**TOWN OF BLYTHEWOOD
BOARD OF ARCHITECTURAL REVIEW AGENDA
OCTOBER 21, 2019 – 6:00 PM
DOKO MANOR
100 ALVINA HAGOOD CIRCLE
BLYTHEWOOD, SOUTH CAROLINA**

B. 2019-06-COA – 221 Blythewood Road (TMS# 15100-05-33) Certificate of Appropriateness for construction of a Zaxby's restaurant (Robert Nutt) (TC) (AO)

To: Board of Architectural Review
From: Staff
Date: October 21, 2019
Applicant: Robert Nutt (MRP Design Group, Inc.)
Subject: Certificate of Appropriateness
TC (Town Center District) AO (Architectural Overlay District)
Location: 221 Blythewood Road
TMS# 15100-05-33

FRONT & REAR
EXTERIOR ELEVATIONS

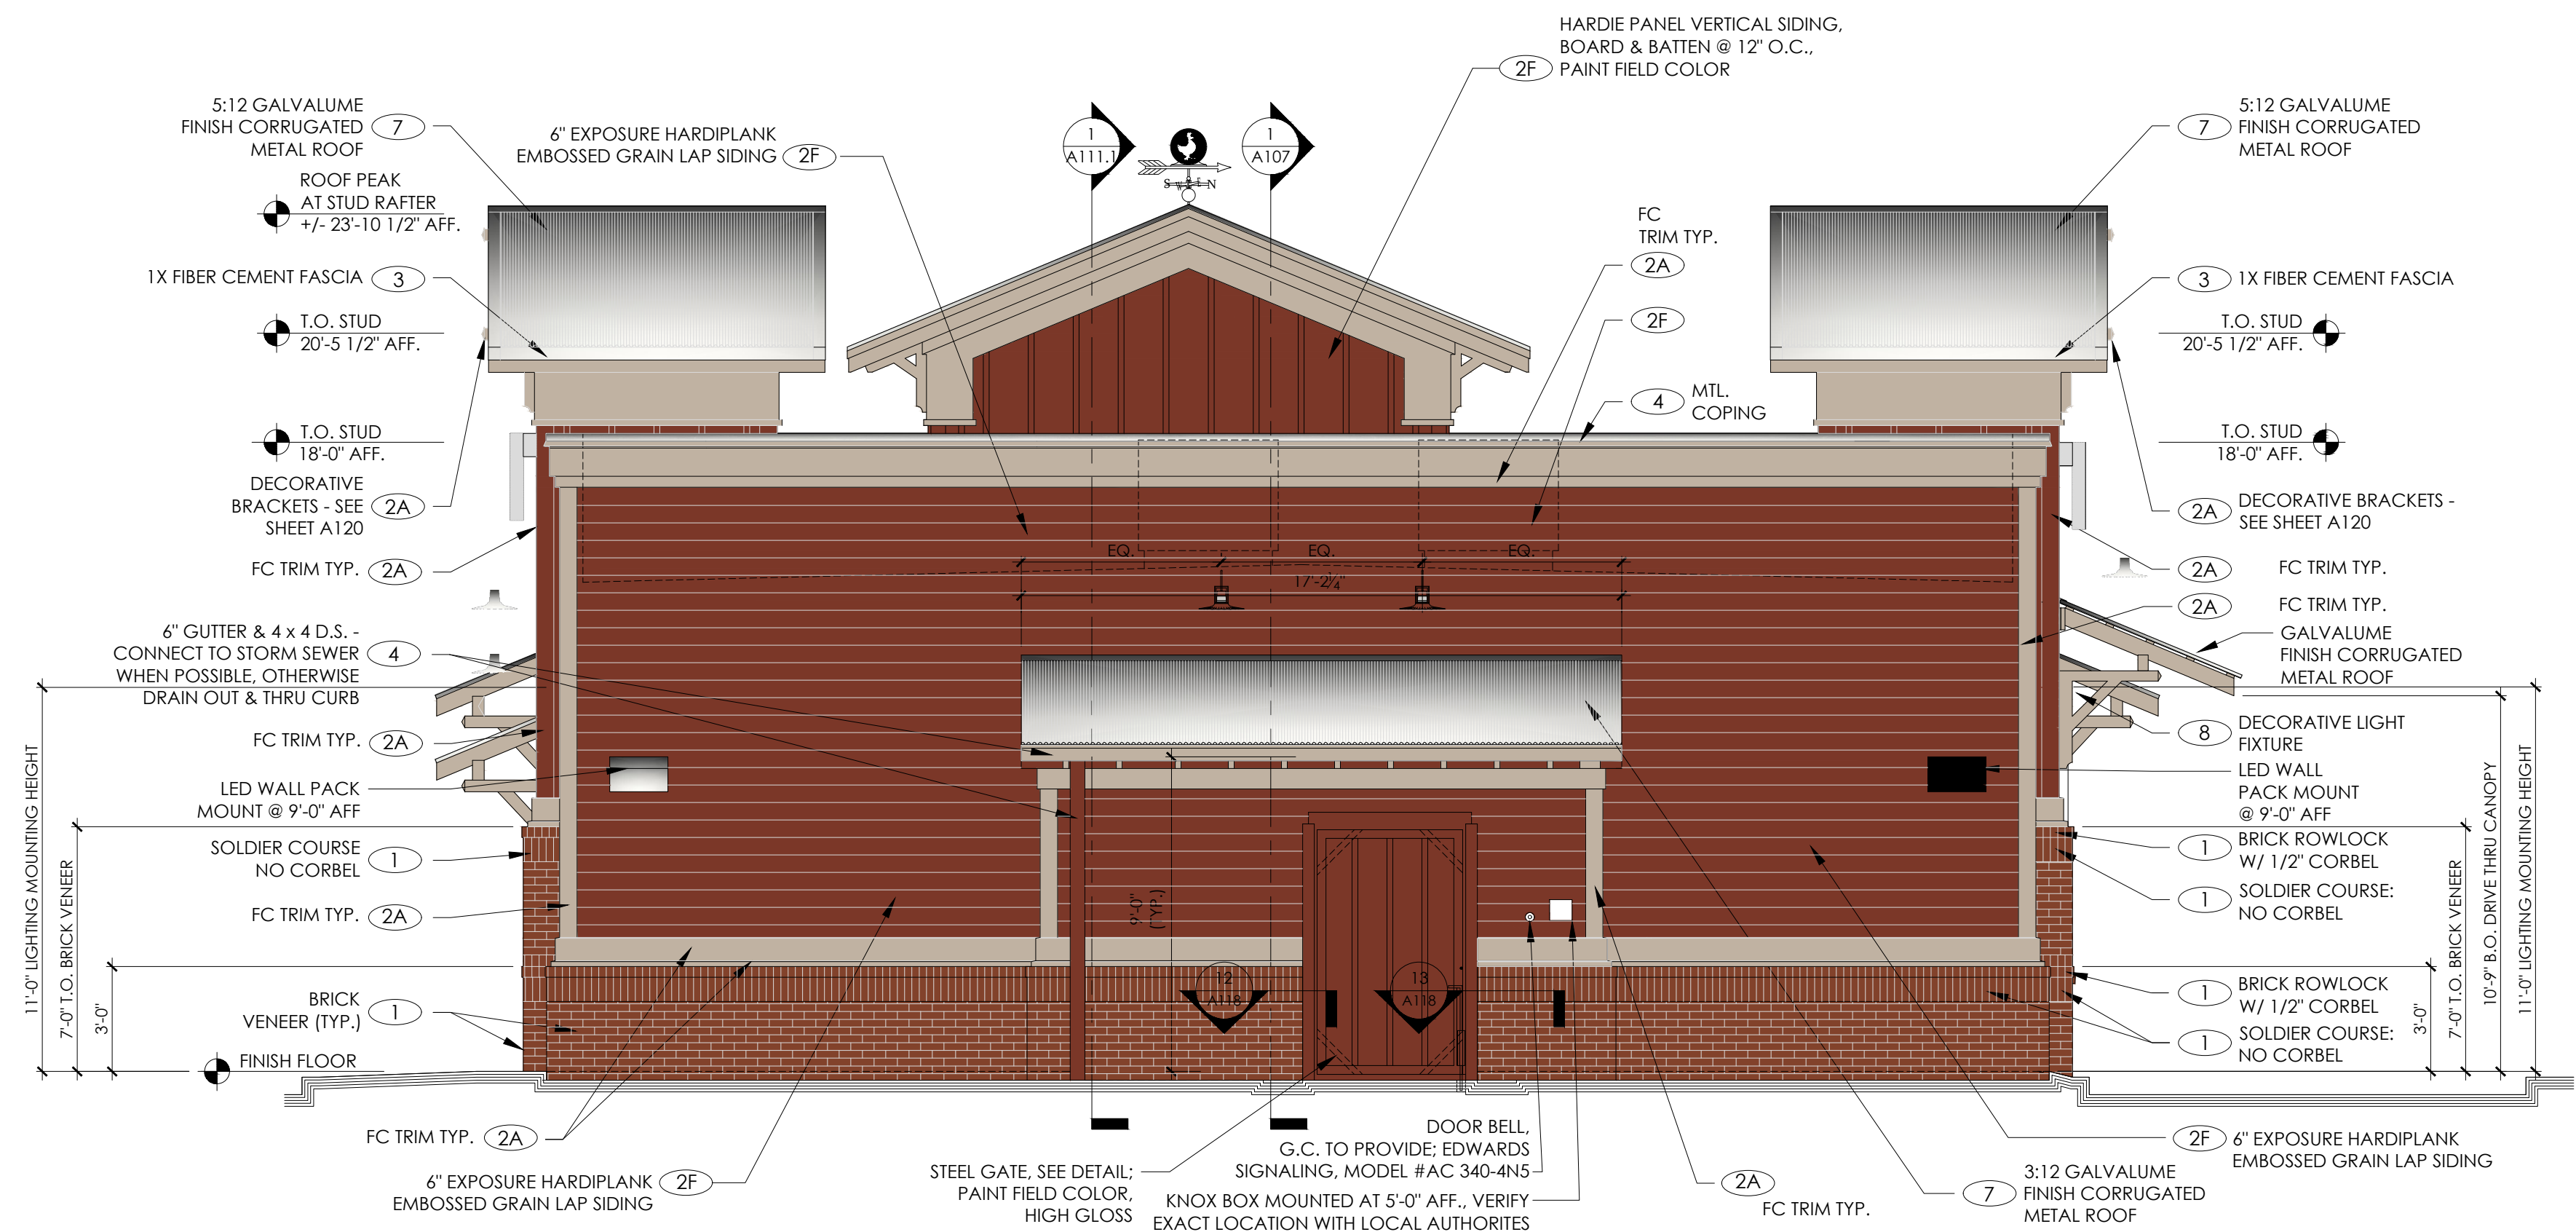
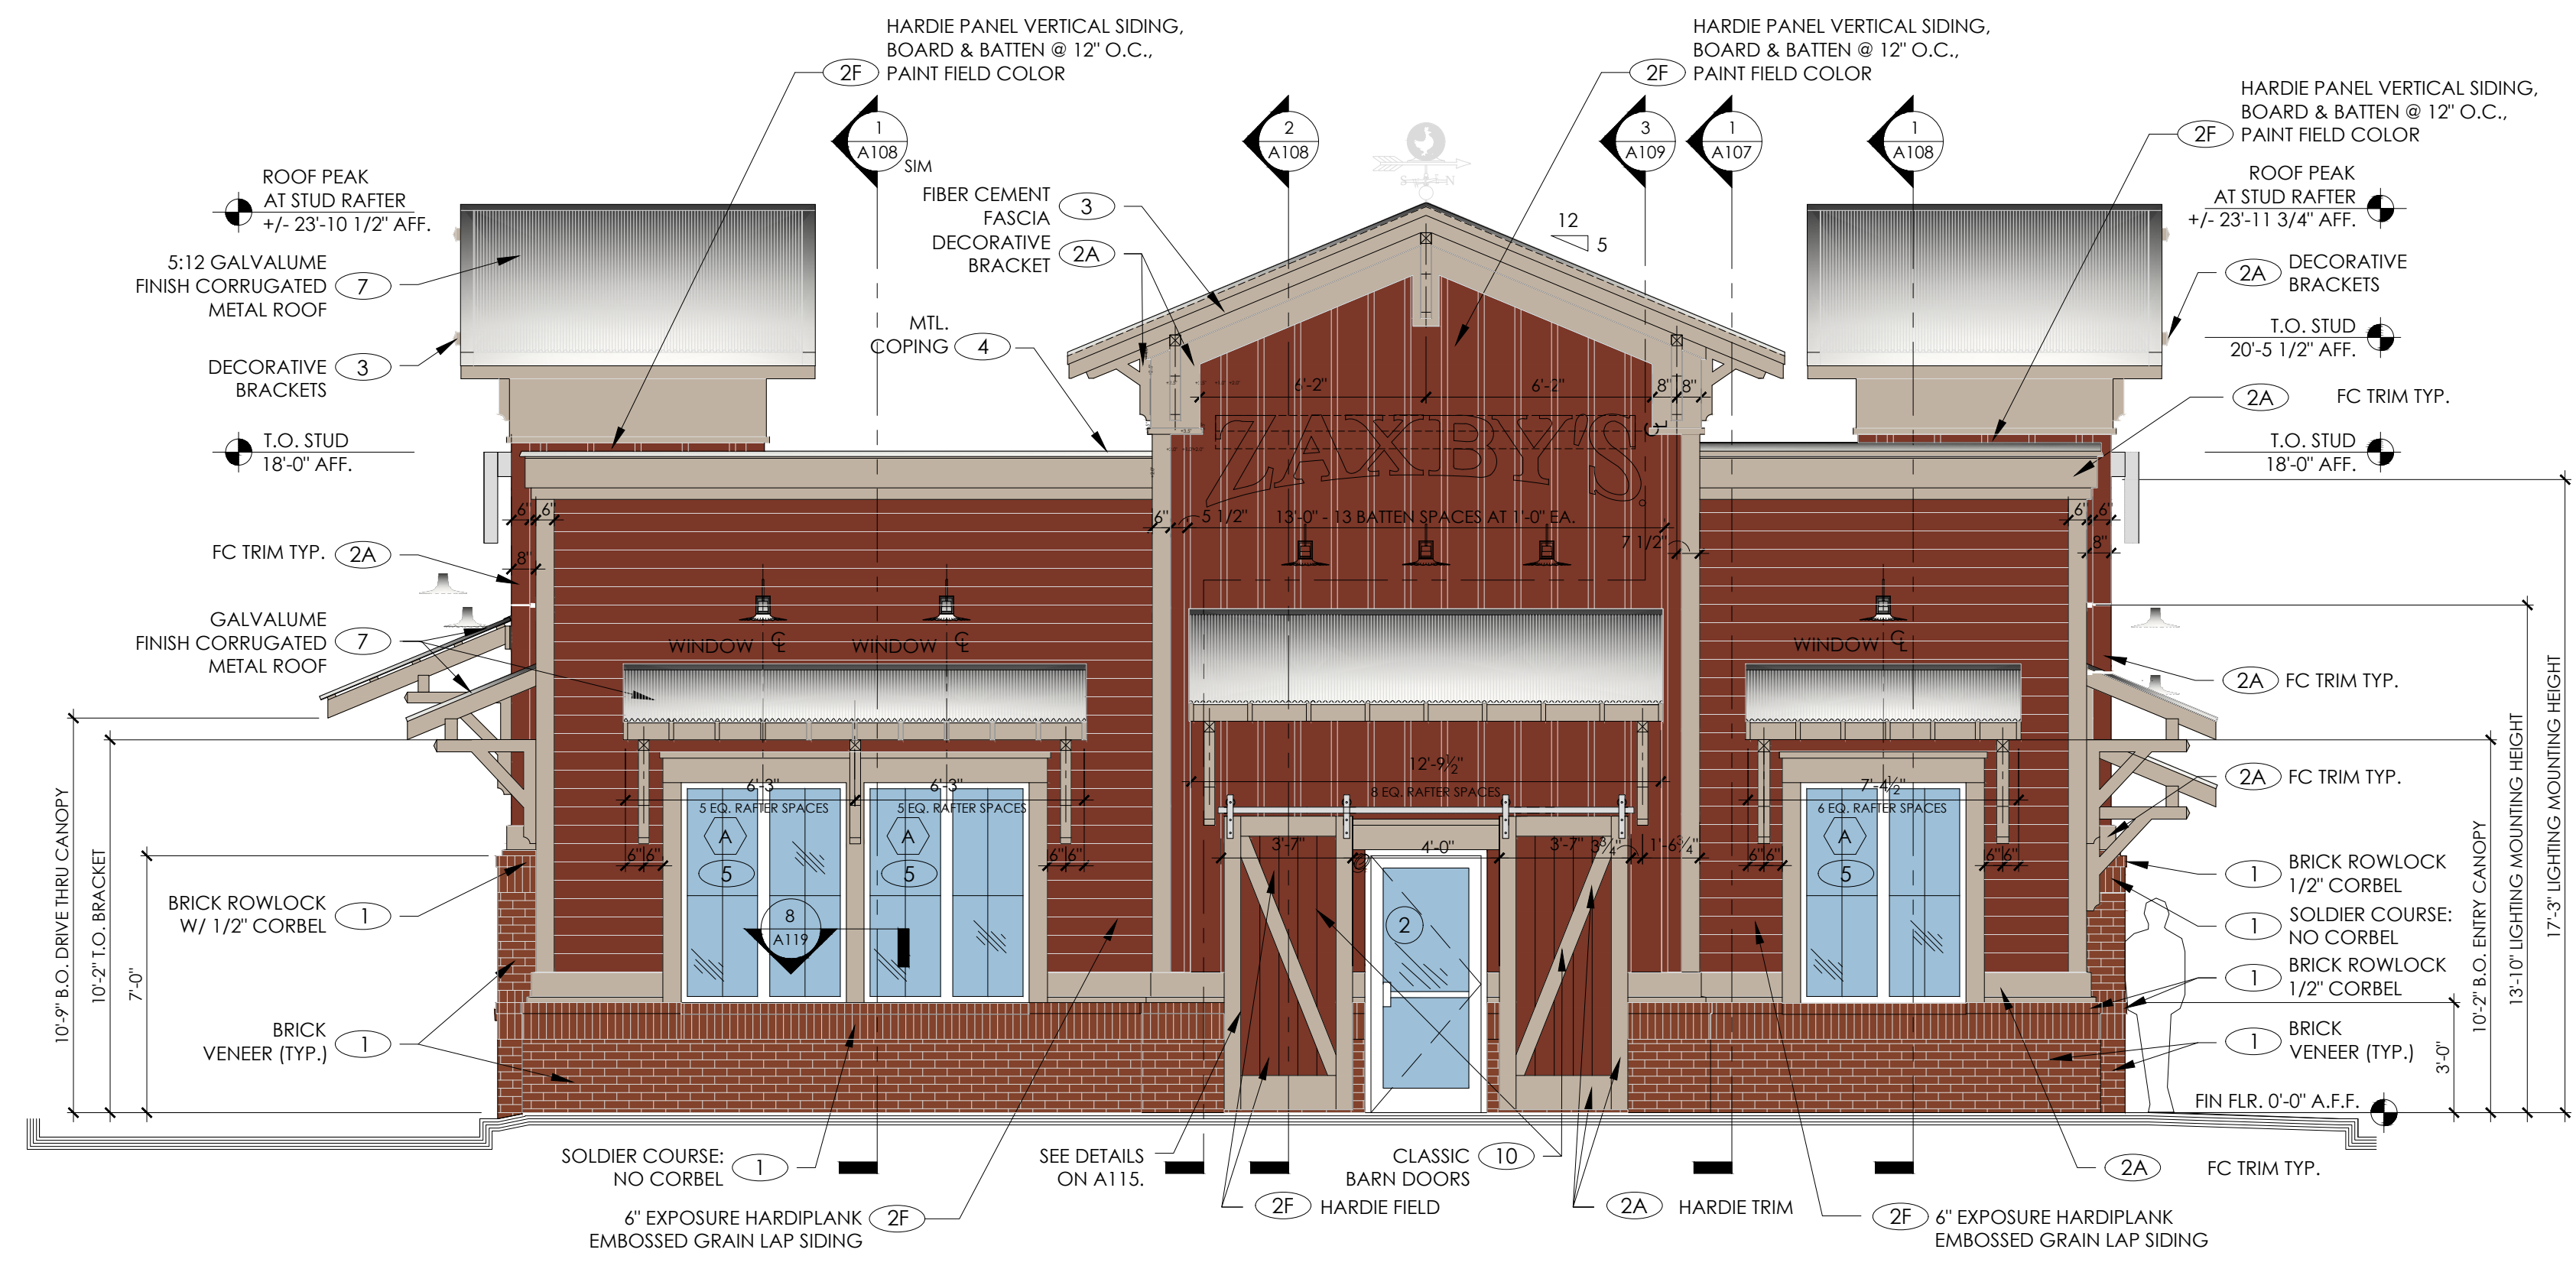
- The subject property is a 1.54 acre site
- The face brick will be a standard 3 5/8" x 2 1/4" x 7 5/8". The mortar joints will be 3/8" thick.
- The exterior finish of Zaxby's building walls shall be primarily comprised of brick, hardiplank siding, wood brackets, and metal awnings.
- The primary brick color will be "Commonwealth"
- The fascia and freize/trim color will consist of a "Balanced Beige"
- The structure will consist of 6" exposure hardiplank embossed grain lap siding in the color "Roycroft Copper Red"
- Gooseneck lighting will be attached to the structure and the fixtures will have a galvanized metal finish

- The roof will be a standing seam metal roof with a galvalume finish
- The window awnings will consist of a standing seam metal roofing material with a galvalume finish
- The building height is proposed at twenty (20) feet
- The front of the building façade will feature classic barn doors constructed out of hardiplank
- Building setbacks are: Front = 25 feet, Rear = 10 feet, Side = 10 feet (§155.182)
- The average street protective yard width shall be 15 feet and shall have a minimum width of 10 feet (§ 155.384.4). The site plan shows 15 feet.
- All mechanical equipment on the ground and roof shall be screened from all sides

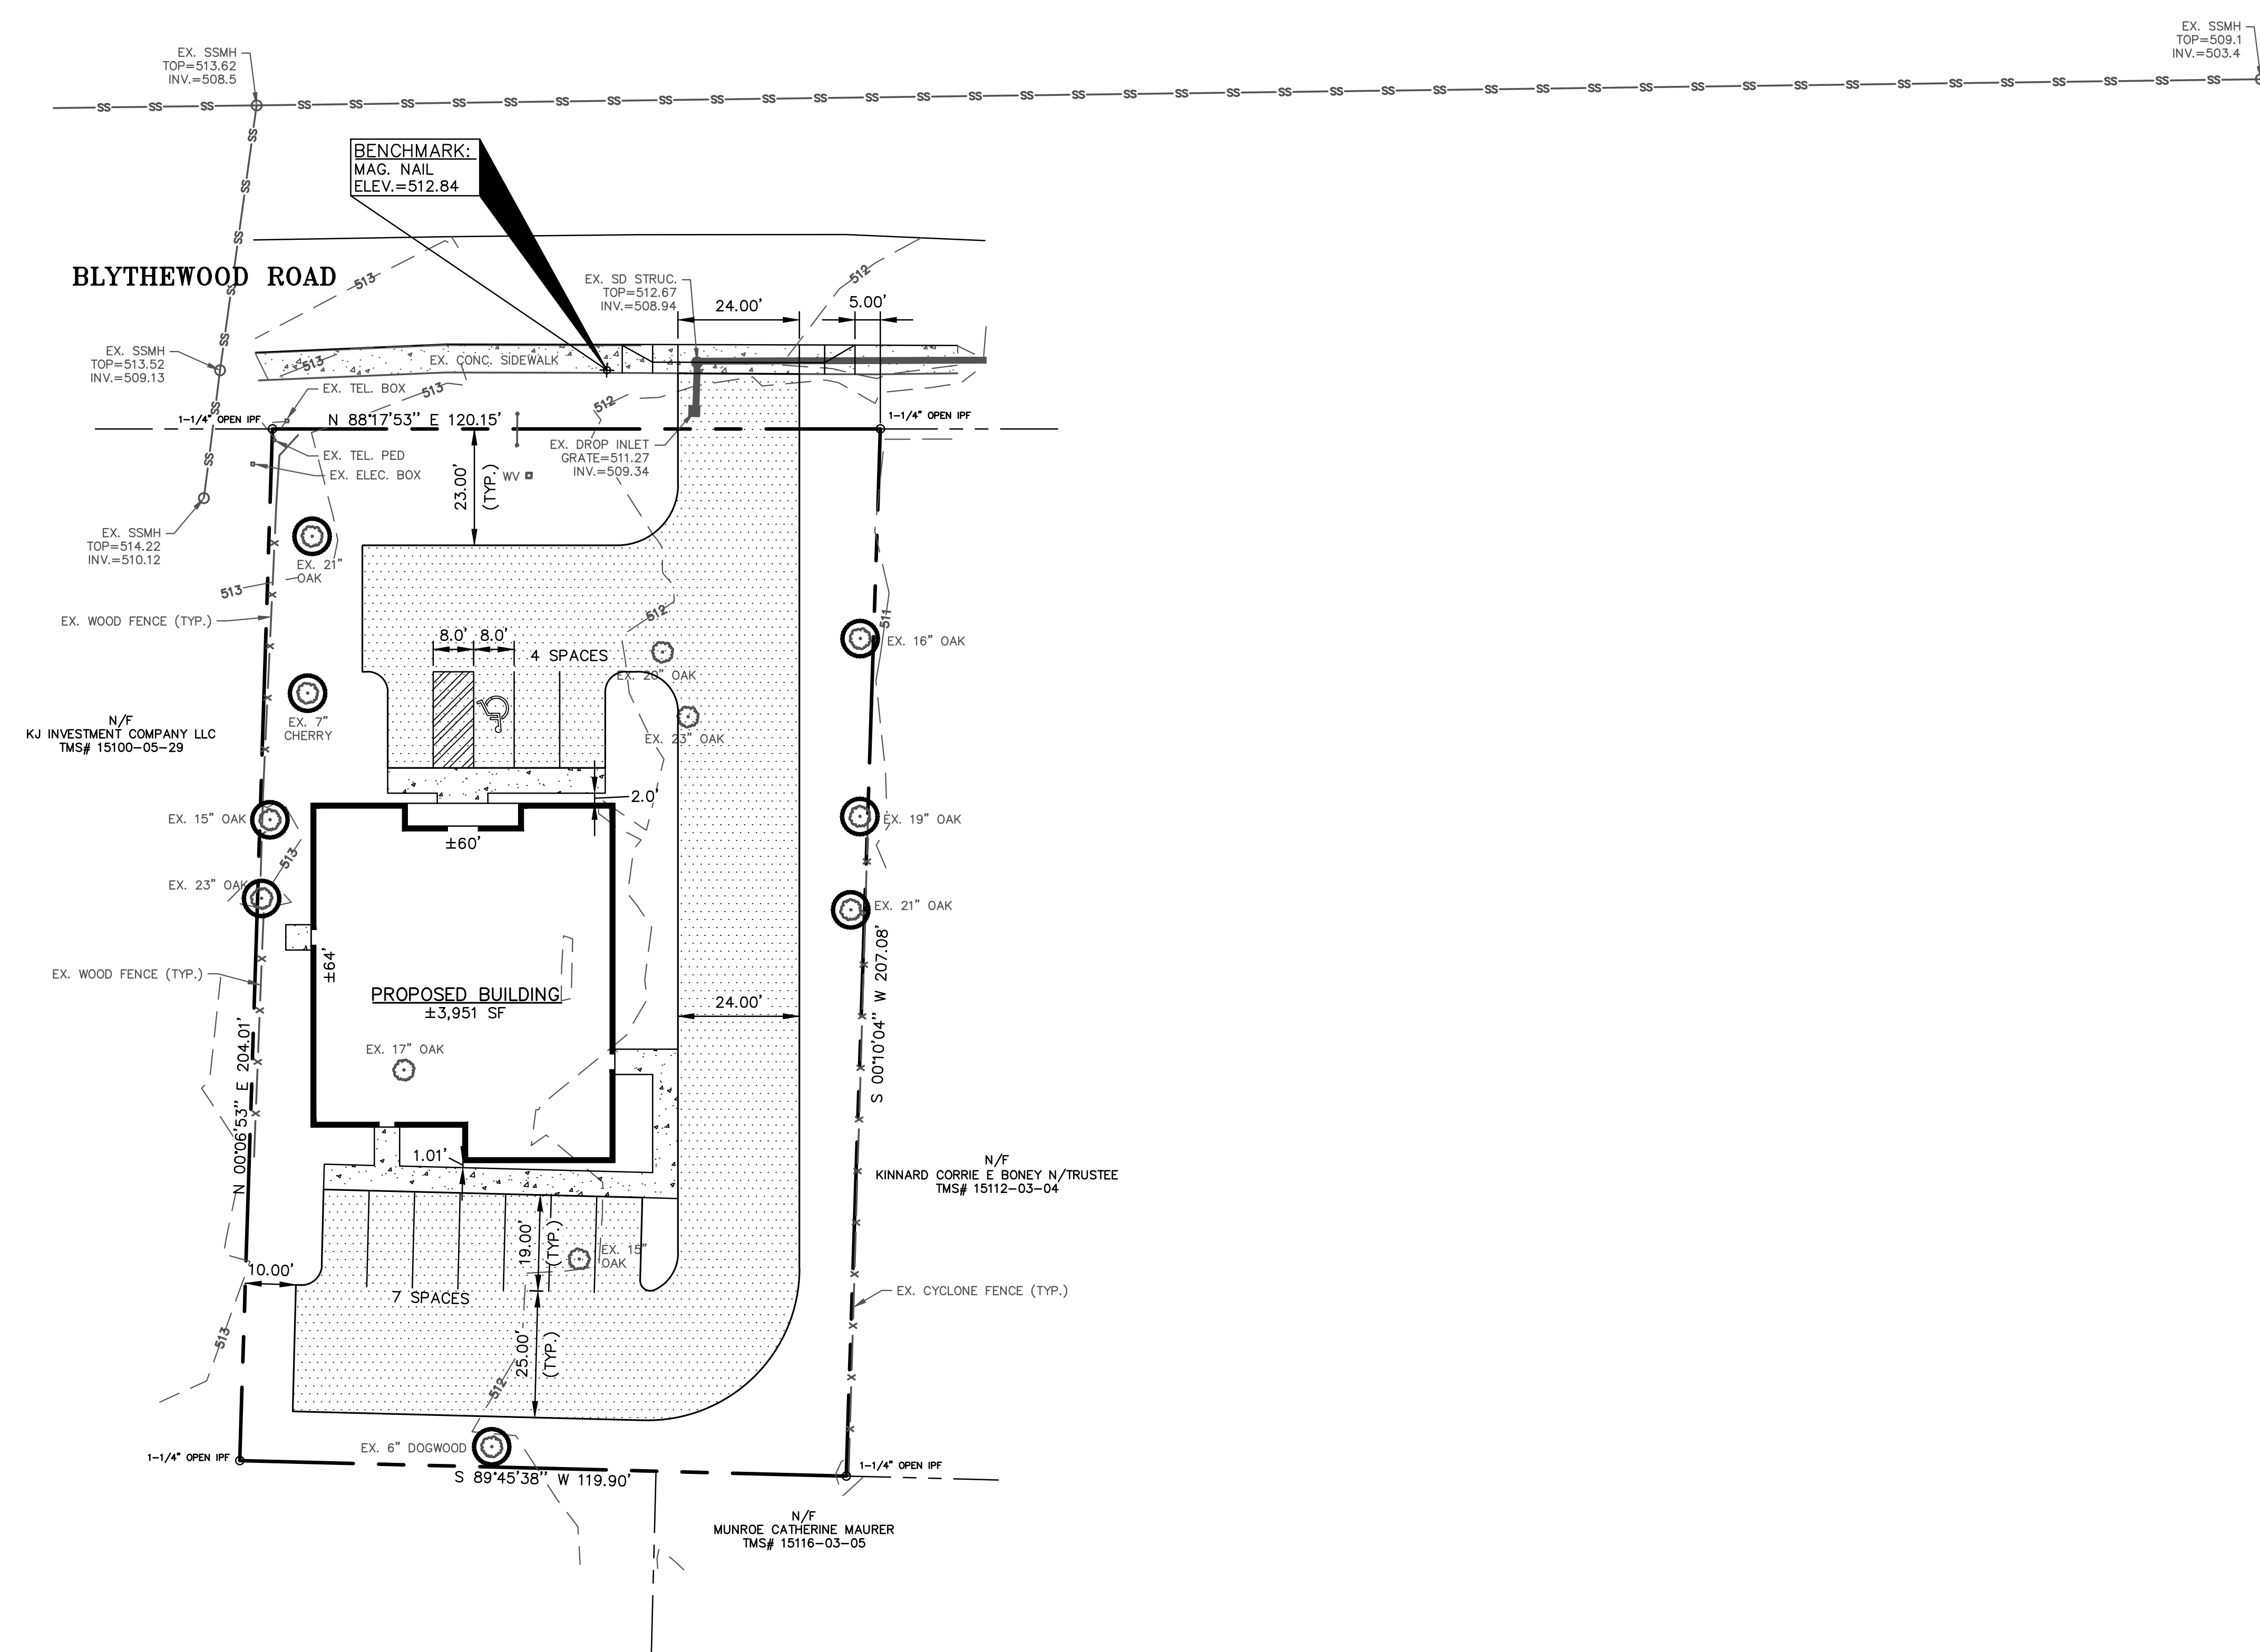
The site plan shows the removal of four existing oak trees on the subject property. Per the zoning ordinance, trees to be removed shall be only those trees necessary to permit the construction of buildings or building additions, structures, driveways, and other authorized improvements (§155.394 D). During the development of the property, the owner shall be responsible for the placement of fencing for any tree and root protection necessary to protect existing vegetation from damage during construction (§155.391).

Side and rear setbacks shall be 10 feet. The structure shall have a minimum front setback of 25 feet to establish landscape, curb and sidewalk façade zones (§155.182 G).

Specific shrub/tree plantings/species quantity/location will be required and may be delegated to staff. Proper irrigation and maintenance of landscaping shall be required. The preserved plus planted tree density shall meet the minimum of 30 units per acre. To determine compliance, a tree inventory will have to be established.
